Accessibility Survey

City of Downey Telegraph Road & Birchbark Avenue

Date of Inspection 4/29/2017

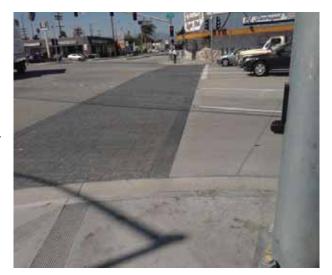
Tactile arrow is either not raised enough or does not contrast with background.

On-Site Finding Not Compliant

Make sure that the tactile arrow is raised at least 1/32 inch and contrasts with background.

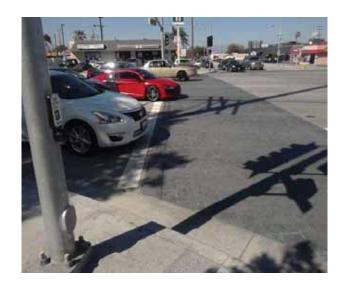
Push button distance from crosswalk is not compliant.

On-Site Finding 168.00 inches

Provide a compliant push button.

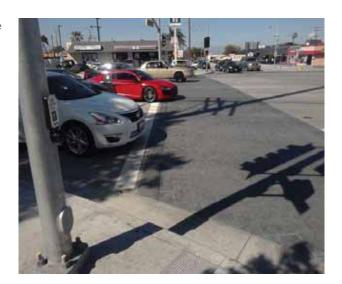
There is not enough clear ground space at the push button.

On-Site Finding 40.00 inches

Provide compliant clear ground space at the push button.

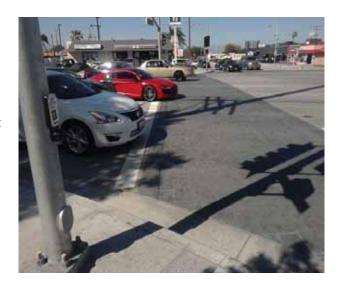
There is no street name information related signage at the signal.

On-Site Finding Not Found

Provide compliant signage that includes street name.

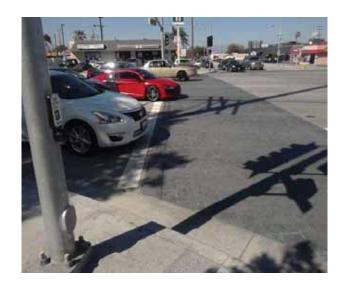
No locator tone provided for the pedestrian signal indicator.

On-Site Finding Not Found

Provide locator tone for the indicator.

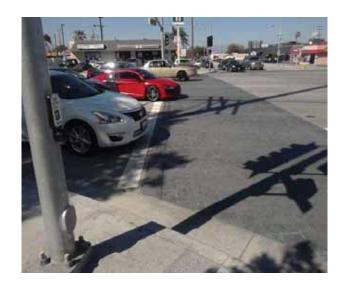
No walk interval tone provided for the pedestrian signal indicator.

On-Site Finding Not Found

Provide compliant walk interval tone.

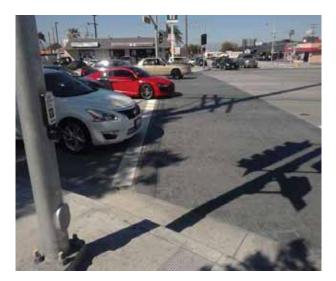
There is no vibro-tactile indication at the signal.

On-Site Finding Not Found

Provide compliant vibro-tactile indicator at the signal.

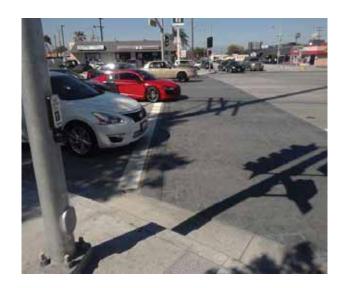
Speech walk message is not provided at the signal.

On-Site Finding Not Found

Provide compliant speech walk message for the signal.

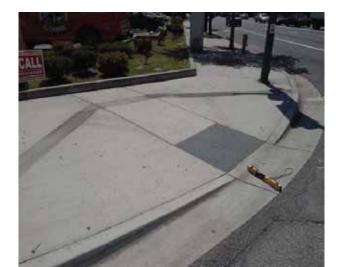
There is not enough top landing clear length.

On-Site Finding 47.00 inches

Provide a level top landing with enough clear length.

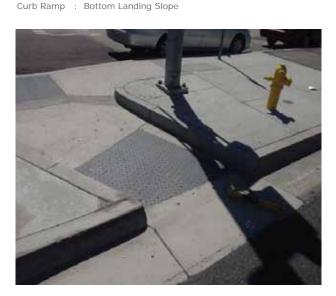
The bottom landing of the curb ramp is on the street, and the slope of the bottom landing is not compliant.

On-Site Finding 6.80 percent

Ensure the bottom landing slope is compliant and provides a smooth transition.

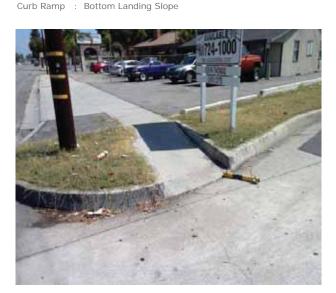
The bottom landing of the curb ramp is on the street, and the slope of the bottom landing is not compliant.

On-Site Finding 13.20 percent

Ensure the bottom landing slope is compliant and provides a smooth transition.

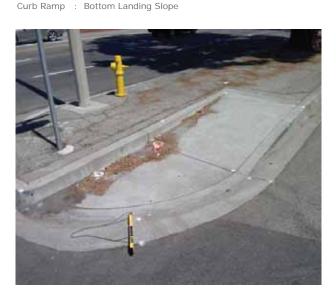
The bottom landing of the curb ramp is on the street, and the slope of the bottom landing is not compliant.

On-Site Finding 15.50 percent

Ensure the bottom landing slope is compliant and provides a smooth transition.

Change in Level West of City of Santa Fe Springs @ 33.950942864348, - 118.095054477453

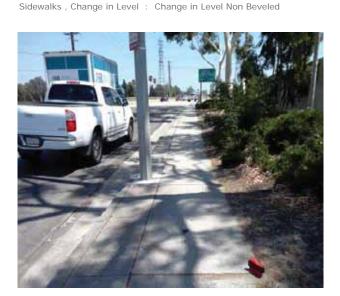
There is a change in elevation greater than recommended value.

On-Site Finding 0.50 inches

Ensure that the change in elevation is within the recommended value.

Change in Level West of Passons Boulevard @ 33.957525081265, - 118.105319291353

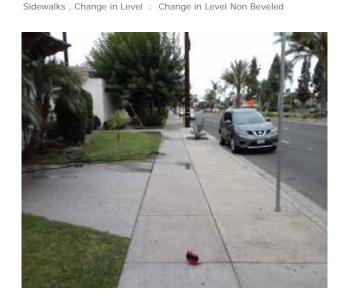
There is a change in elevation greater than recommended value.

On-Site Finding 0.62 inches

Ensure that the change in elevation is within the recommended value.

Change in Level West of Passons Boulevard @ 33.958180271544, - 118.106266111135

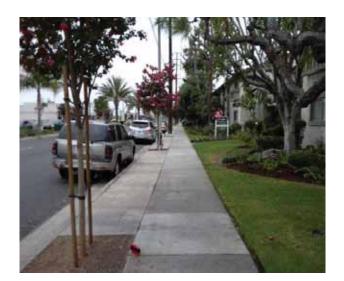
There is a change in elevation greater than recommended value.

On-Site Finding 0.50 inches

Ensure that the change in elevation is within the recommended value.

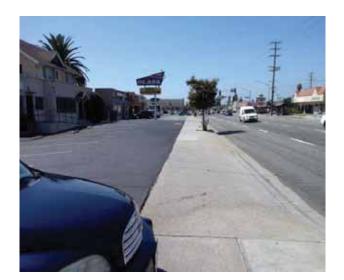
There are no detectable warnings where the pedestrian route crosses vehicular traffic.

On-Site Finding Not Found

Provide detectable warnings.

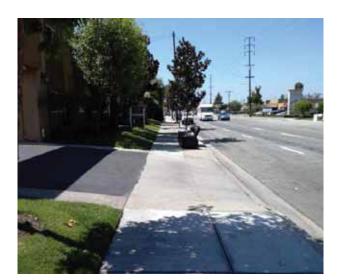
There are no detectable warnings where the pedestrian route crosses vehicular traffic.

On-Site Finding Not Found

Provide detectable warnings.

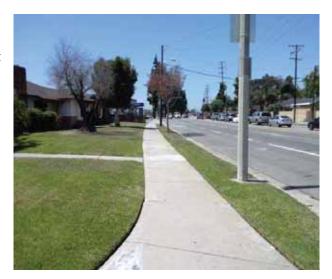
Sidewalk cross slope is not compliant.

On-Site Finding 4.40 percent for 305.00 feet

Repave the sidewalk surface with the recommended cross slope.

Change in Level West of Lowman Avenue @ 33.971294139516, -118.119815289974

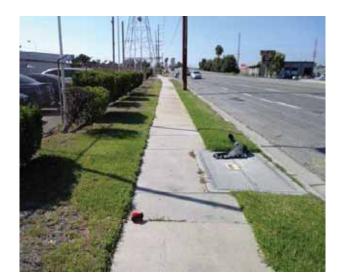
There is a change in elevation greater than recommended value.

On-Site Finding 1.00 inches

Ensure that the change in elevation is within the recommended value.

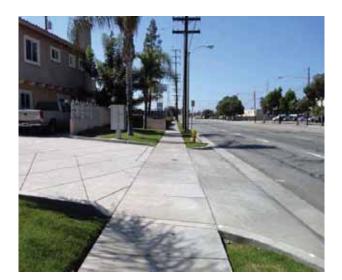
There are no detectable warnings where the pedestrian route crosses vehicular traffic.

On-Site Finding Not Found

Provide detectable warnings.

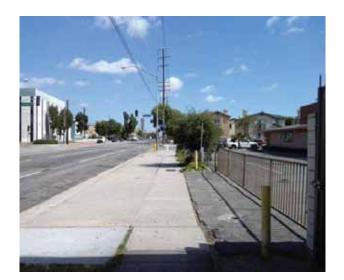
There are no detectable warnings where the pedestrian route crosses vehicular traffic.

On-Site Finding Not Found

Provide detectable warnings.

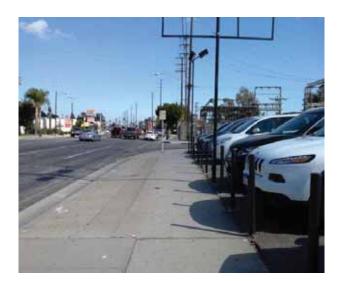
There are no detectable warnings where the pedestrian route crosses vehicular traffic.

On-Site Finding Not Found

Provide detectable warnings.
